UNITED STATES
NUCLEAR REGULATORY COMMISSION
WASHINGTON, D.C. 20555-0001

SUBJECT: REQUEST FOR ADDITIONAL INFORMATION (RAI) ON RISK-INFORMED
INSERVICE TESTING (RI-IST) PILOT PLANT - COMANCHE PEAK STEAM
ELECTRIC STATION UNITS 1, AND 2 (TAC NOS. M94165 AND M94166)

RISK-INFORMED INSERVICE TESTING (RI-IST) PILOT PLANT

Figure 2

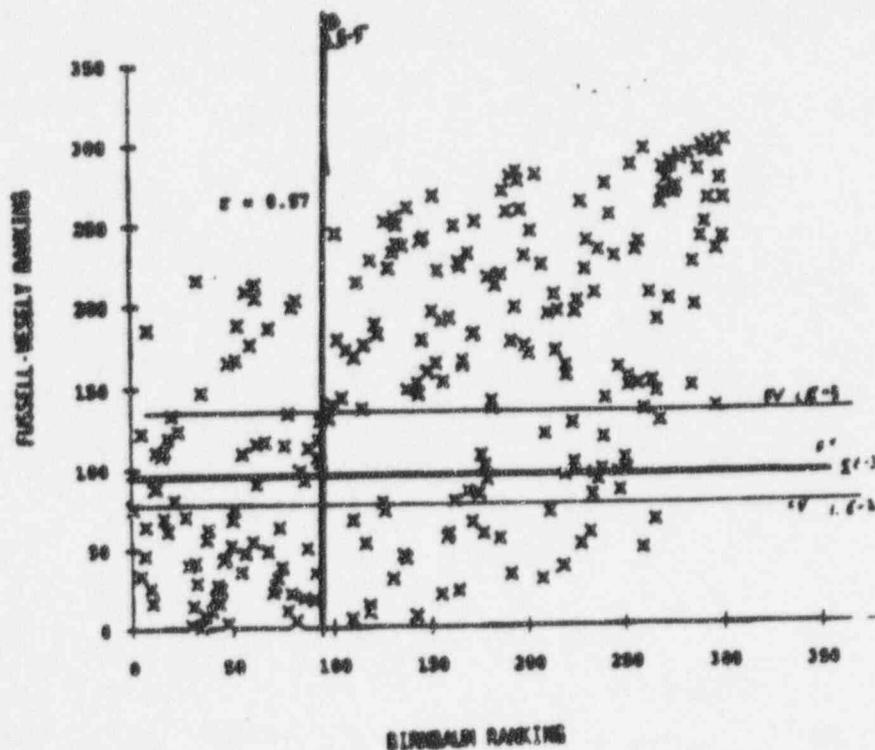
Another potential risk-ranking approach that we have given some consideration to is shown in the plot of Figure 2. Some typical basic event data are shown plotted as Fussell-Vesely importance ranking vs Birnbaum ranking. The data points are shown in some tentative quadrants, Hi-Hi, Lo-Lo, Hi-Lo, etc. Would the Expert Panel gain any useful insights by evaluating such a plot? Would it have any significant effect on the ranking results?
